WATER-RIGHT DOCKET

CLEVELAND CREEK. WATERTON RANGER STATION WATER SYSTEM

Subject: Waterton Ranger Station Water System, Drawing 5363-A,
Docket 6, Glacier

To: Director
From: Hydraulic Engineer, Region Two
Subject: Water Rights, Drawing NP-GLA-5363-A, Waterton Ranger Station, Glacier National Park

Attached are duplicate prints of Drawing No. NP-GIA-5363-A which show the results of water right surveys in the Waterton Ranger Station area. These prints show the existing diversion and pipeline serving the ranger station and outbuildings.

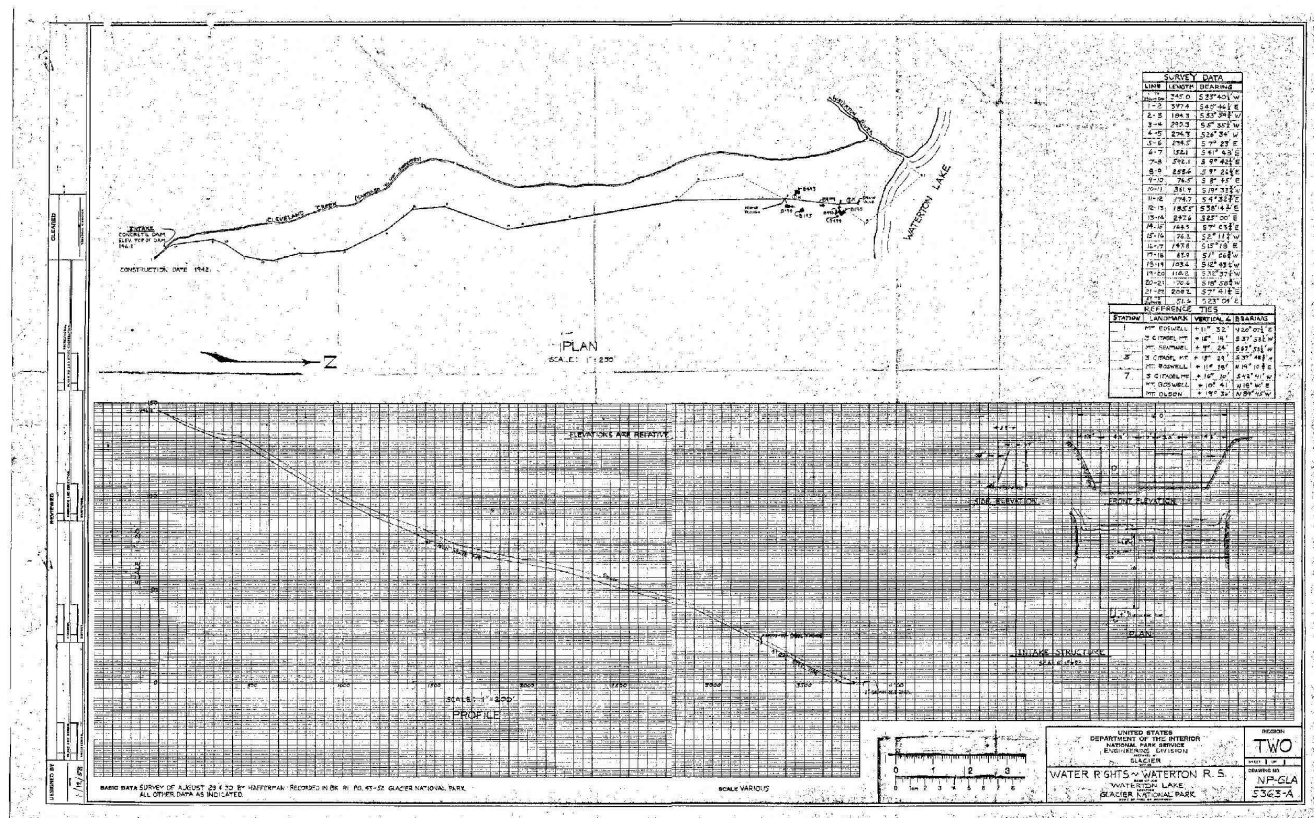
I am not sure that the land has been subdivided in this area. If not, a tie from old and proposed new points of diversion to both of Waterton Creek, and theoretical projection of section lines for description in a county filing would suffice. An actual section corner tie would be preferred. Angular ties to monuments on each side of the lake at the Canadian border would also be desirable if they are visible from some points in the area. The drawing might show these details as an insert, but no map will be needed with the county filing. All ties can be quite approximate in this case.

Because of the international nature of Waterton Lake, I believe that the filing should give both old and new points of diversion when it is made. It should also give the date of first development and water use at the area, and indicate that the new system is an enlargement or replacement, as the case may be.

The reconstruction of the water system included in the 1961 construction program will not change the point of diversion, but the final system alignment to be supplied later by the Superintendent should be included with the filing of the water right with the State Engineer.

The 1961 MISSION 66 Construction Program calls for reconstruction of the entire system, except the diversion. As soon as the reconstructed line is established, we will amend this drawing and forward revised copies to you.
